**Oakdale West Industrial Estate Stage 3 SSD 9794683 – Modification Application 1  
19 Emporium Avenue, Kemps Creek**

This Modification Report has been prepared by *Keylan Consulting Pty Ltd* (Keylan) on behalf of *Goodman Property Services (Aust.) Pty Ltd* (the Applicant).

The request is submitted to modify the State Significant Development (SSD) development consent for Stage 3 of the Oakdale West Industrial Estate (OWE) (SSD 9794683), under Section 4.55(1A) of the *Environmental Planning and Assessment Act 1979* (EP&A Act).

Figure 3: Proposed modified layout (Source: SBA)

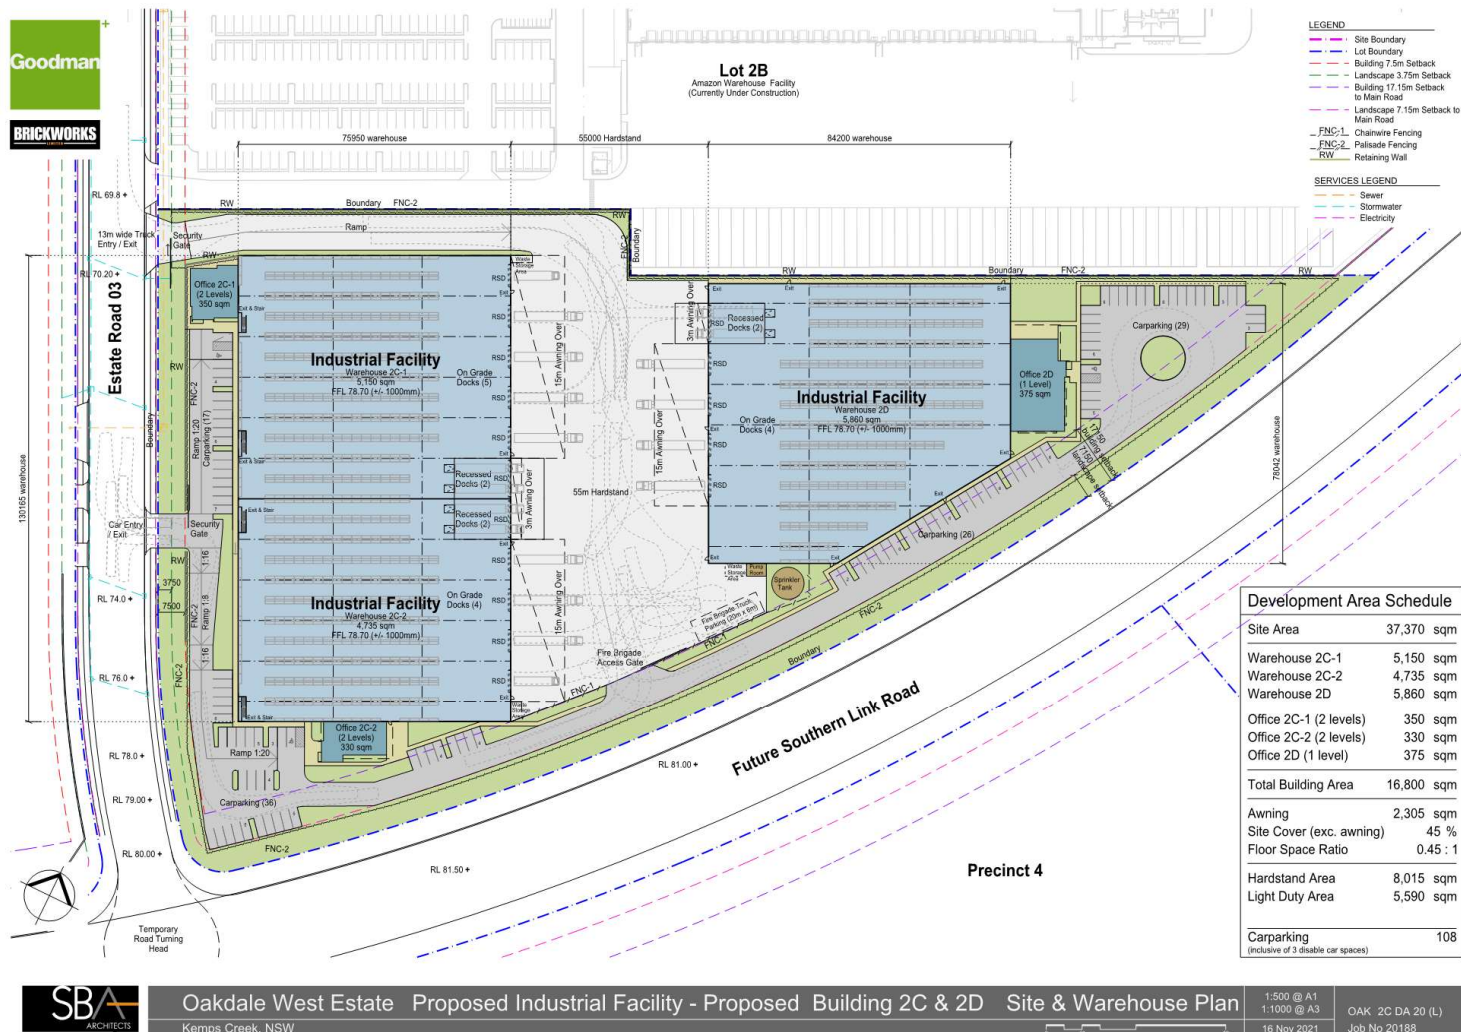
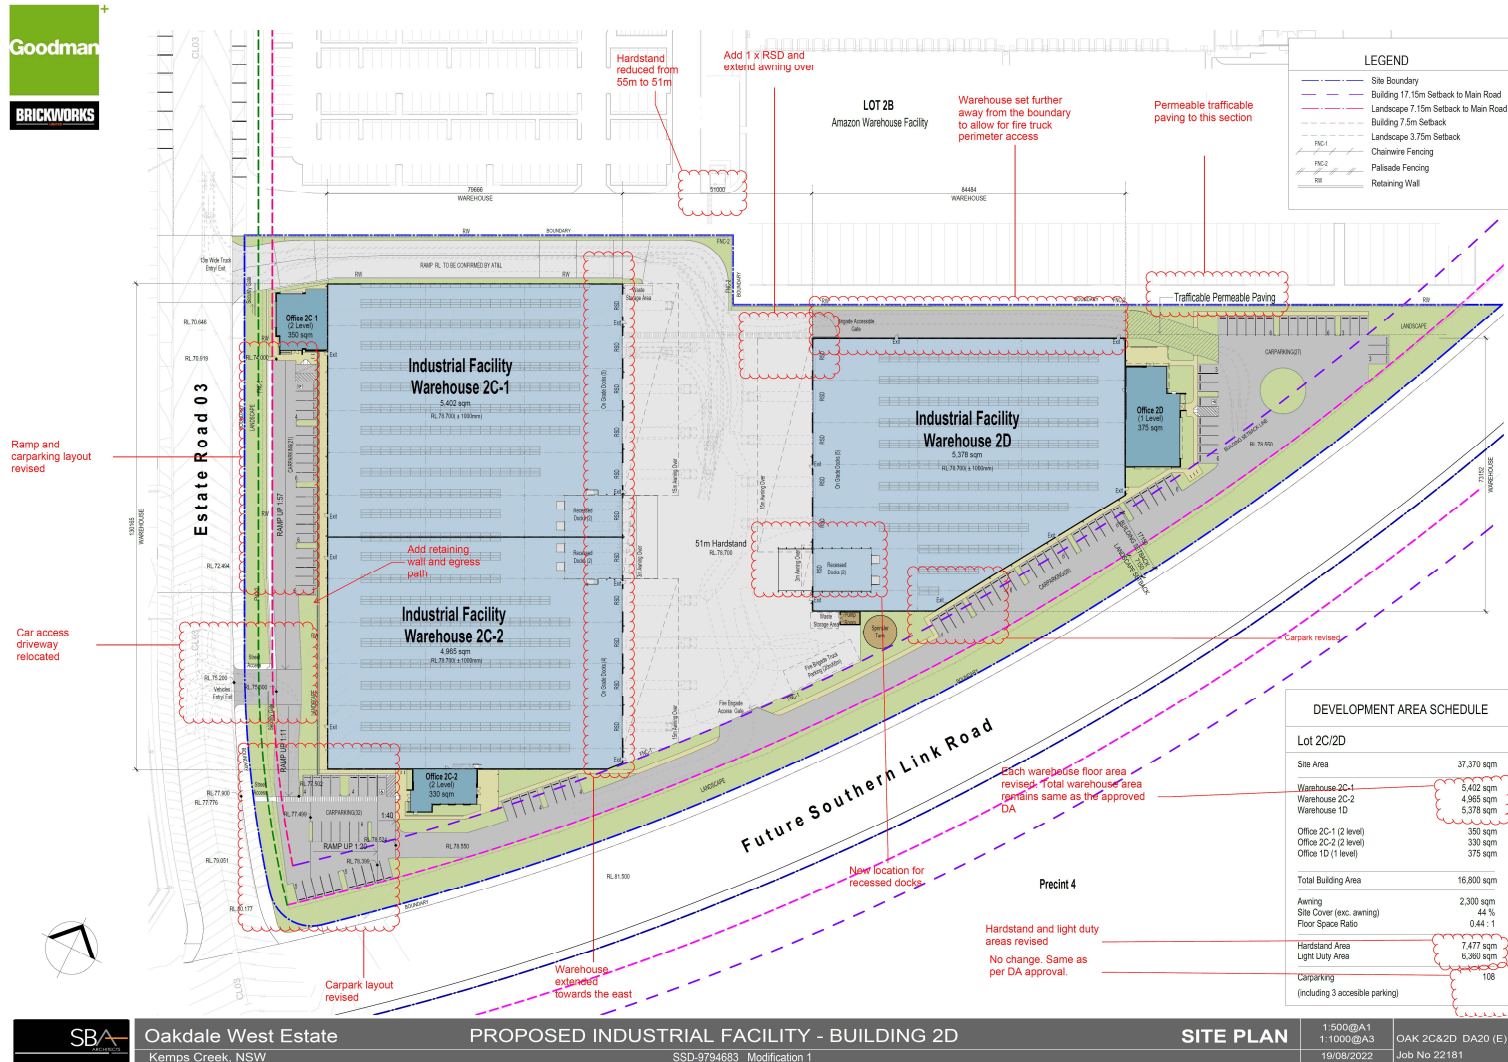
The modification application includes a new fire access pavement along the northern perimeter of Building 2D and associated minor changes to the layout of the warehouse buildings and car parking of both Building 2C and Building 2D.

The reconfiguration of Building 2D includes a relocation of the recessed docks to enable fire vehicles access, additional roller shutter door dock and a relocation and extension of the awning over at-grade docks. The reconfiguration of Building 2C includes a 3m eastern extension of the warehouse building and a revised retaining wall along the western wall to provide pedestrian access along the western perimeter of the building.

The proposed modification also includes a relocation of the access driveway on Emporium Avenue approximately 31.2 m to the south. The revised access driveway enables improved grades of the internal roads and minimises interference between entering vehicles and the parking areas for Building 2C1.
